CMD 25-H12-REF3 CNSC Staff Submission

Reference Package 3 for CMD 25-H12 CNSC Staff Submission on NexGen Energy Ltd. Licence Application to Prepare Site and Construct the Rook I Project

Classification	Unclassified
Type of CMD	References
CMD Number	CMD 25-H12.REF3
Original CMD	CMD 25-H12
Public hearing date	09-12 February 2026
SharePoint ID	QQQVZZNDK725-166150894-9660
Summary	This document contains documents referenced in the Environmental Assessment Report appended to 25-H12, to be placed on the Record for the proceeding.
Actions required	There are no actions requested of the Commission. This CMD is in support of the actions and recommendations set out in CNSC staff CMD 25-H12.

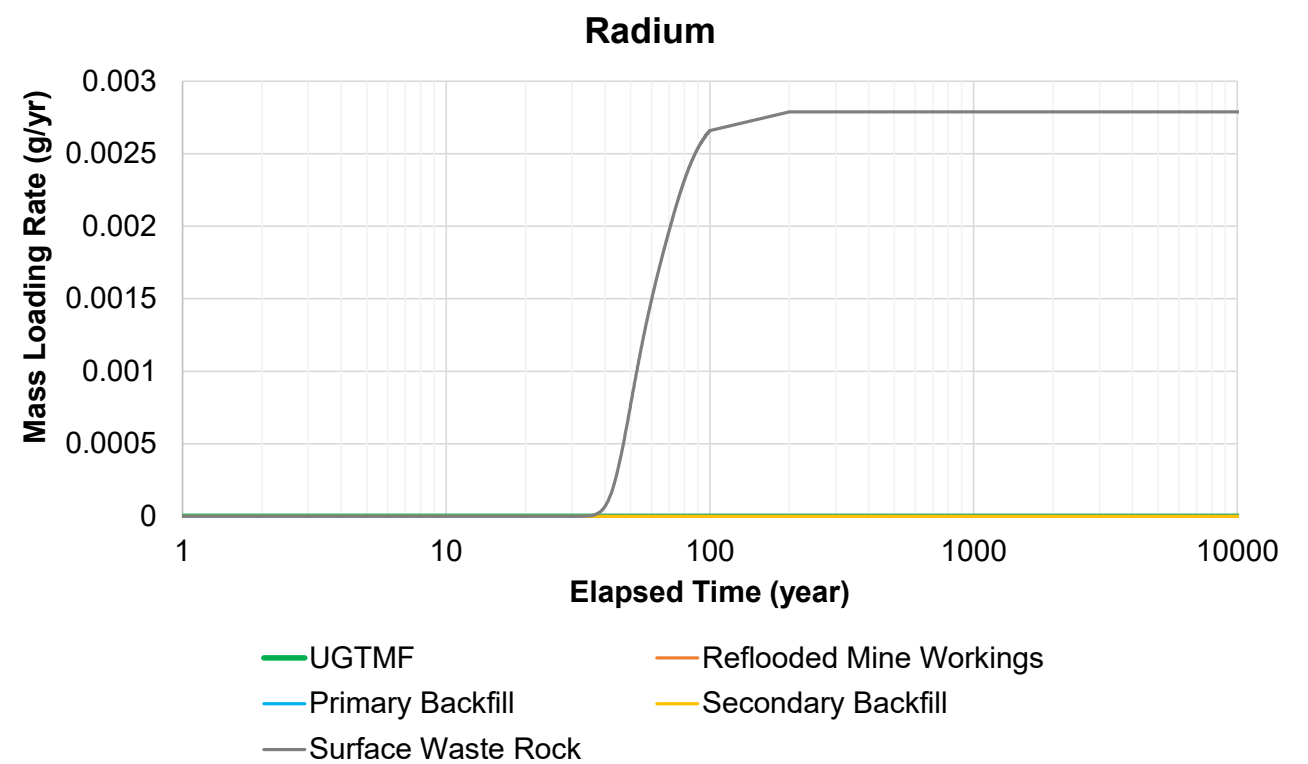
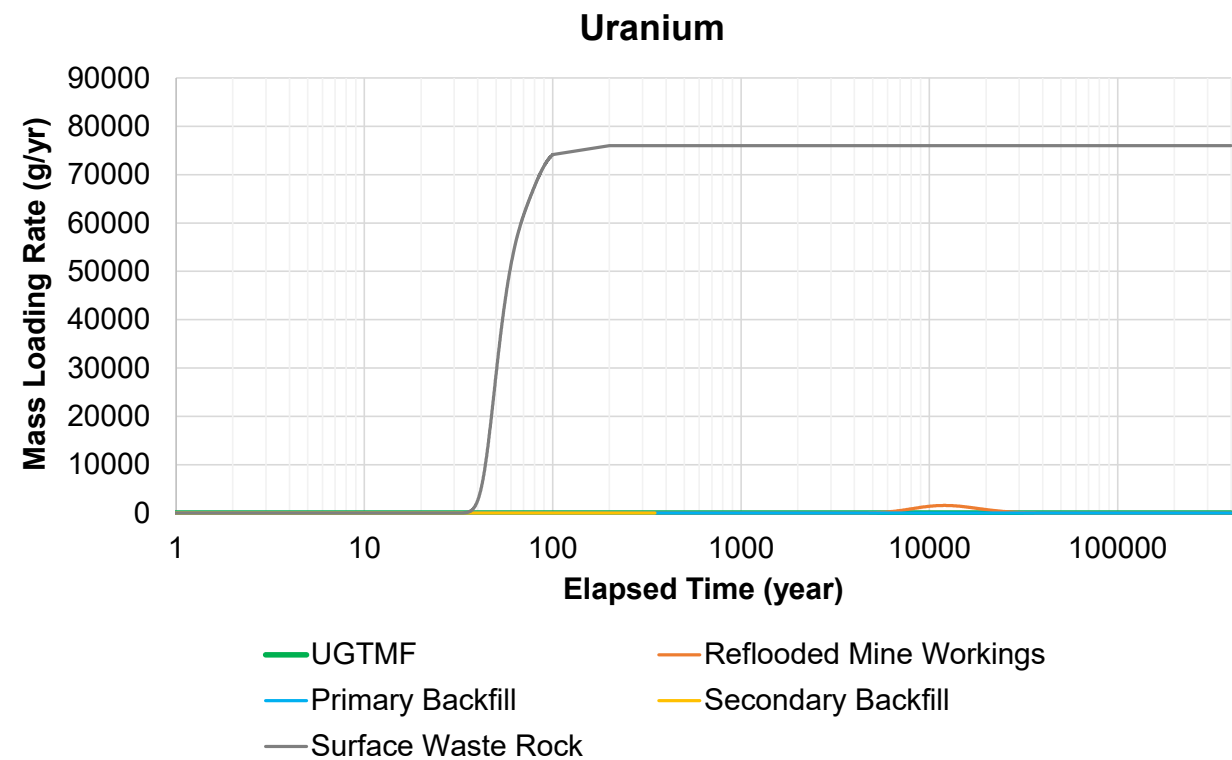
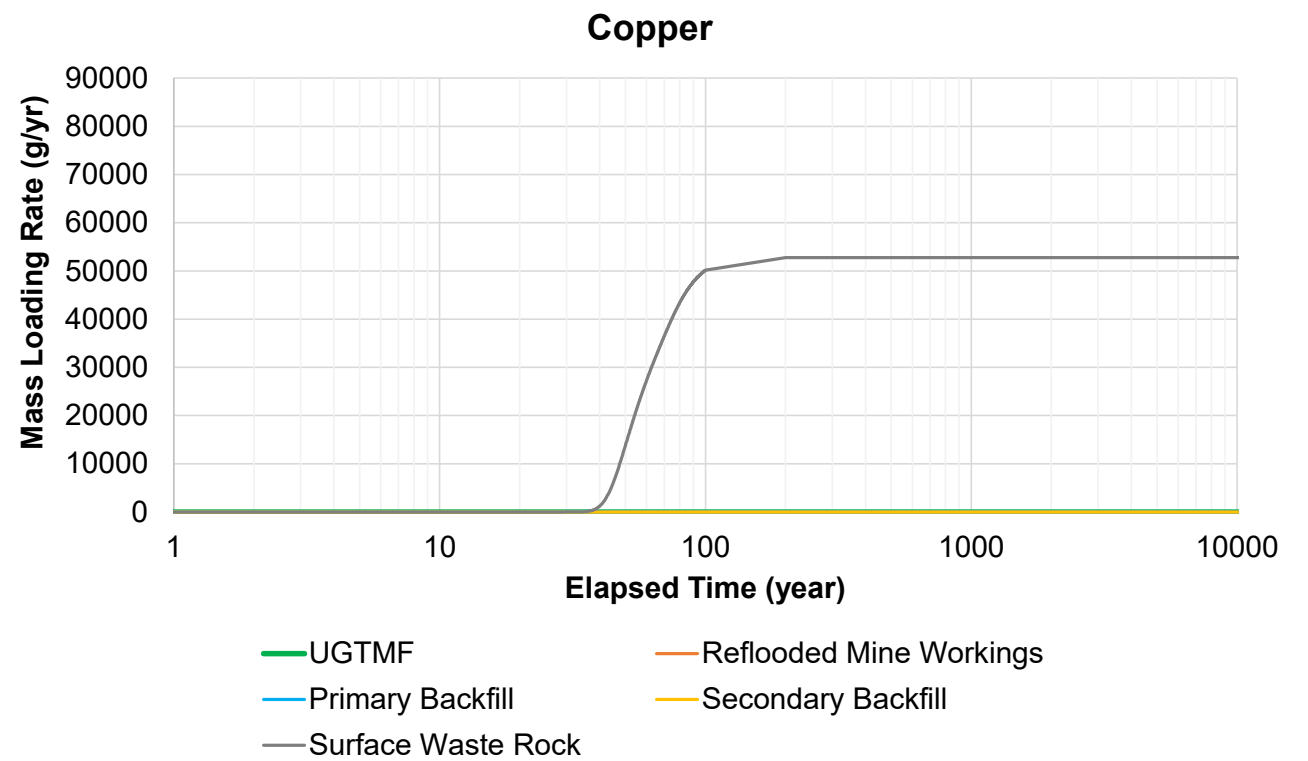
Part 1 - Provide details on how the advective flux of 0.55 m³/d from the UGTMF and 2.7 m³/d from the RMW to Patterson Lake were determined (Figure A-17 of Appendix A of Draft EIS TSD XIV). Details related to how mass flux from the UGTMF to Patterson Lake will occur over time should be provided. The requested details should be included within the body of text in Appendix A, with a summary of key parameters and results provided in the body of the EIS.

NexGen confirms that the advective fluxes presented schematically in Figure A-17 of Draft EIS TSD XIV (Groundwater Flow and Solute Transport Modelling Report) are the predicted fluxes from the groundwater model following reflooding of the underground. The underground was sub-divided into four areas (i.e., underground tailings management facility [UGTMF], primary backfill, secondary backfill, and reflooded mine workings) and a local water budget was completed for each of those regions to extract the predicted flow for each zone.

To provide the details requested by the reviewer regarding advective flux, text in Section 3.3 of revised EIS TSD XIV (Groundwater Flow and Solute Transport Modelling Report) will be modified to state the following:

“Figure A-17 provides a schematic illustration of the GoldSim solute transport model identifying the source, pathways, and downstream receptor. Advective fluxes presented in Figure A-17 for the underground (i.e., UGTMF, primary backfill, secondary backfill, and reflooded mine workings) are predicted flow rates from the groundwater model following reflooding of the mine workings. As summarized in Figure A-17, the predicted flux through the UGTMF, primary backfill, secondary backfill, and reflooded mine workings are 0.55 m³/day, 0.32 m³/day, 0.15 m³/day, and 2.7 m³/day, respectively. Pathways and travel length were derived from the groundwater model through particle tracking analysis as detailed in Section 3.3.2, Groundwater Flow Pathways, and Section 4.4, Pathways Delineation and Travel Times.”
